# Plan Commission

### Agenda

| Monday, January 23, 2017 | 7:00 PM | De Pere City Hall Council Chambers |

**SUBJECT:** Recommendation regarding a Revised Site Plan request at 1212 N. Enterprise Drive in De Pere for a warehouse addition and parking lot expansion (Parcels ED-2070 and ED-2069). Applicant: Mach IV Engineering & Surveying LLC

LANDSCAPE NOTES

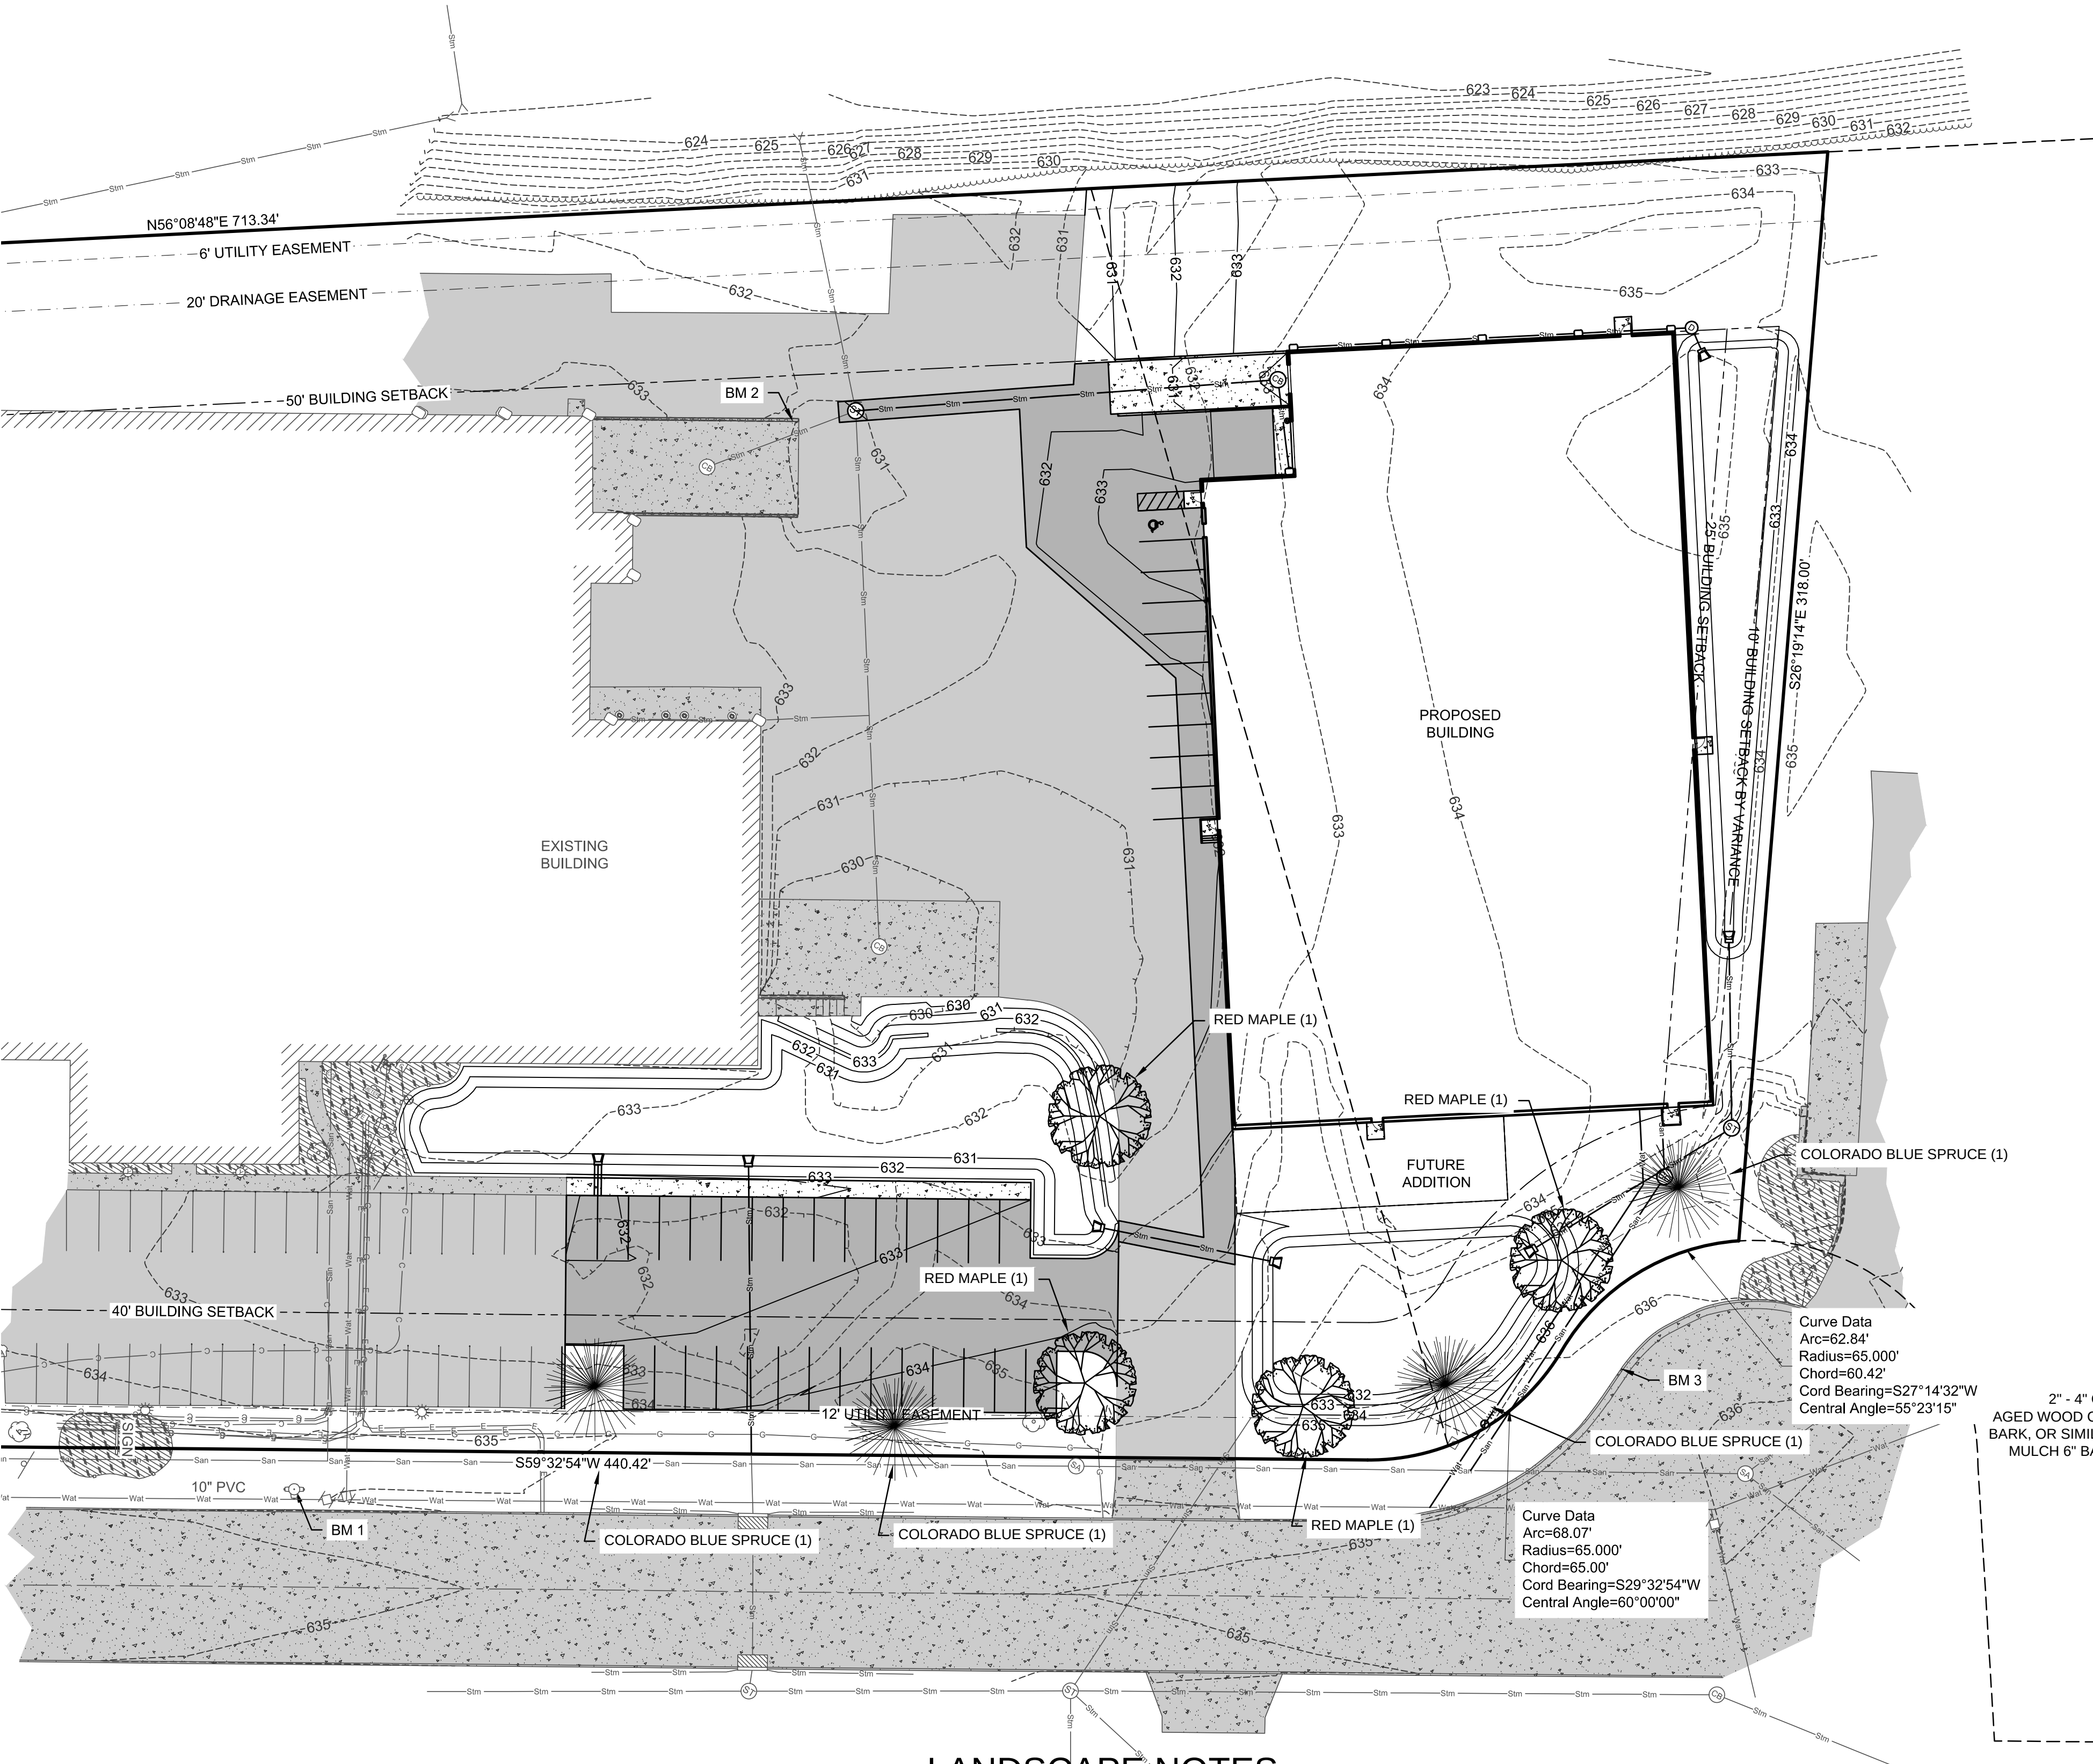
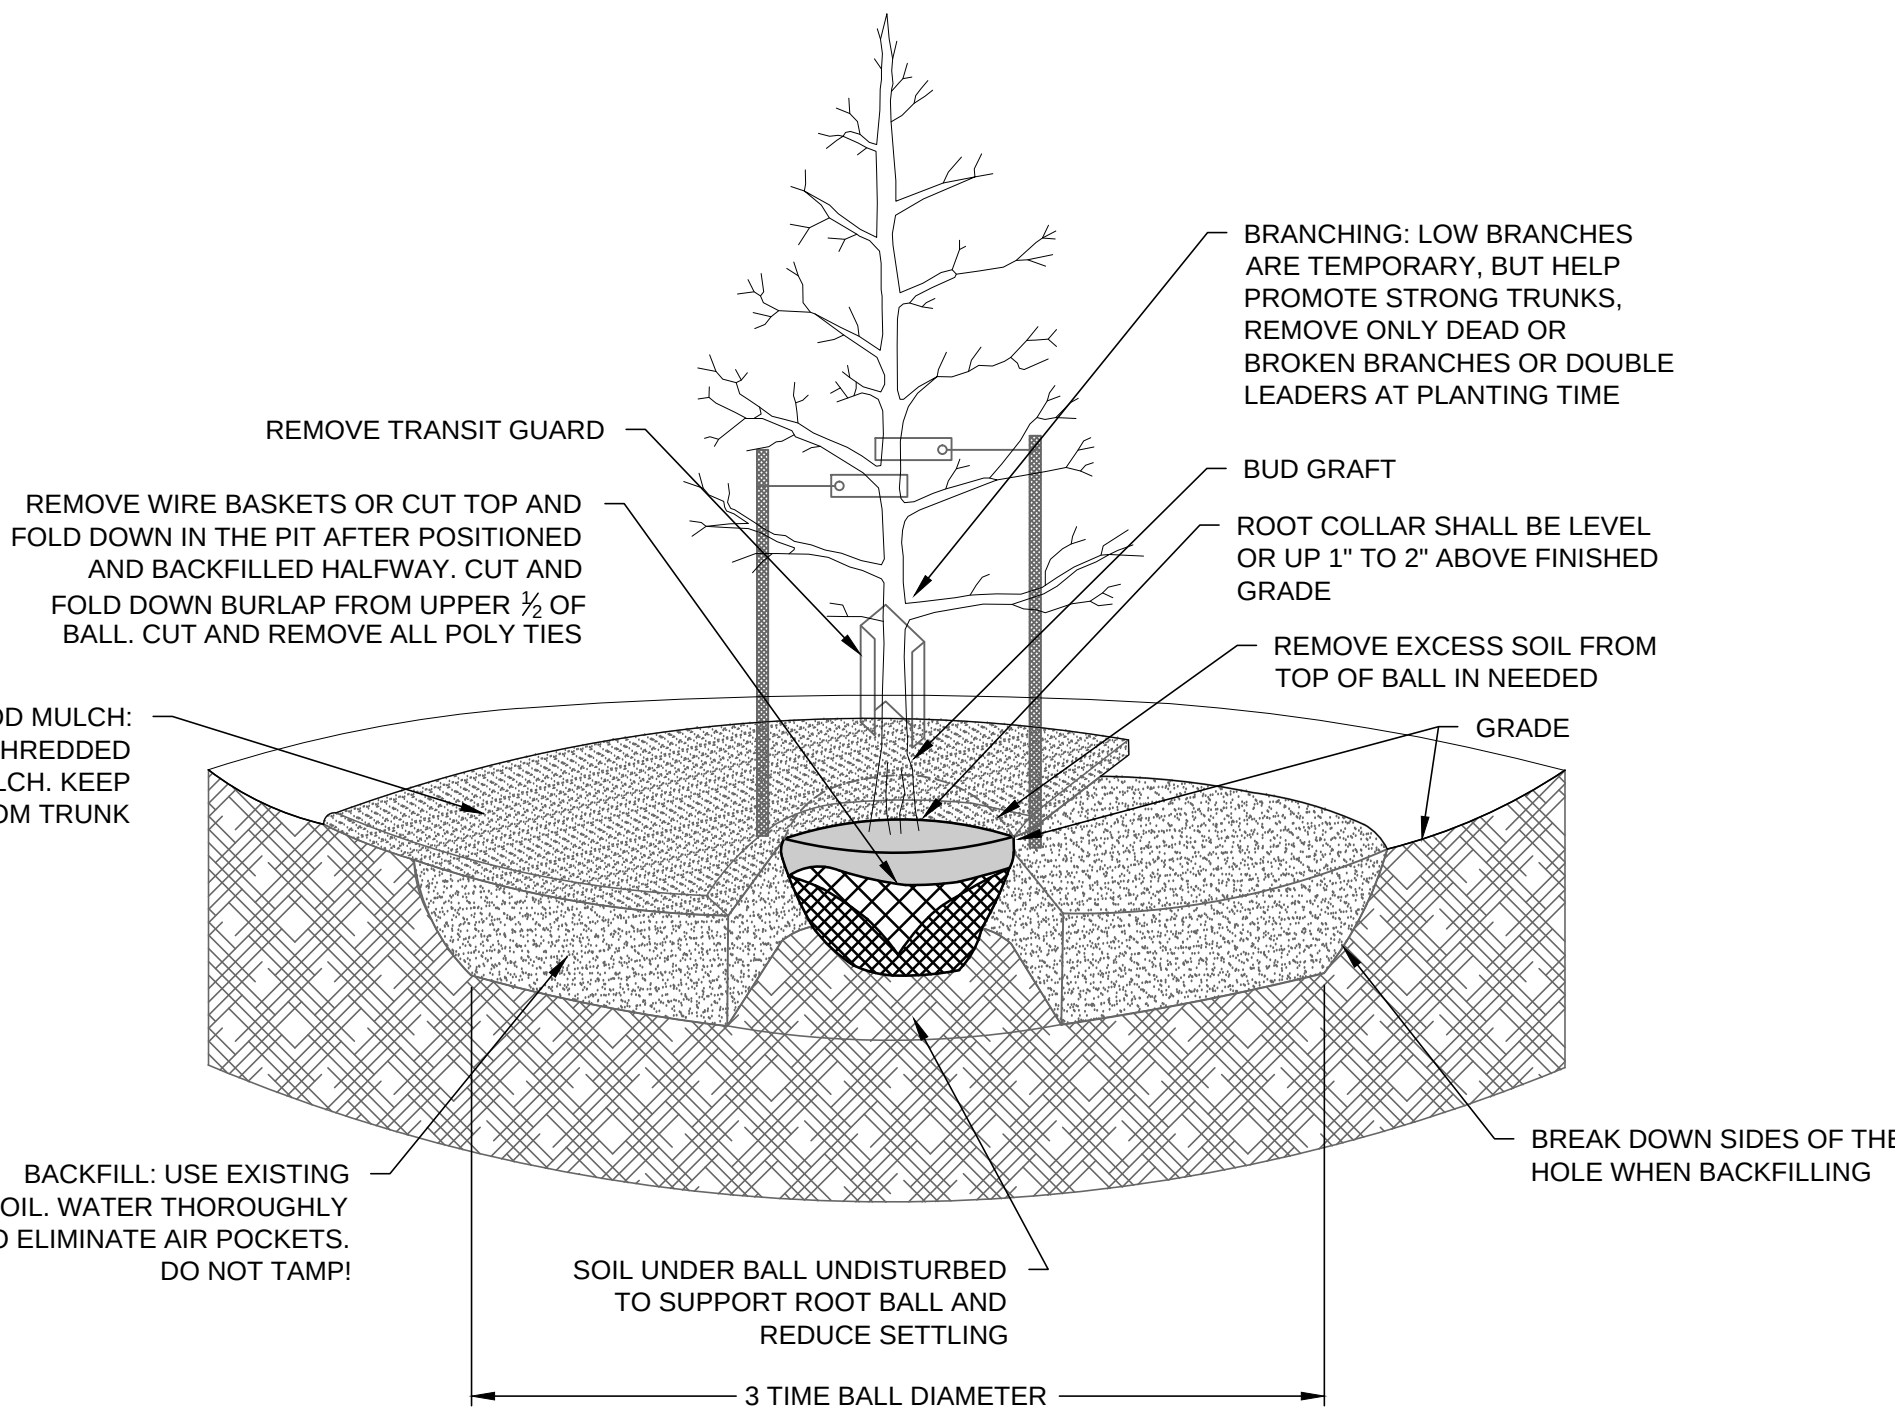
1. Landscape plan has been included with 7 trees. The owner needs to list the trees being planted with their appropriate genus and species name instead of their common name. A "Red" maple can mean really 3 things - a red leaved maple, a maple that gets red leaves in the fall or the Acer rubrum (which is the true 'red' maple).

1. Provide a landscape Plan. No Landscape Plan is included in the site plan. Added. See Sheet L1.0
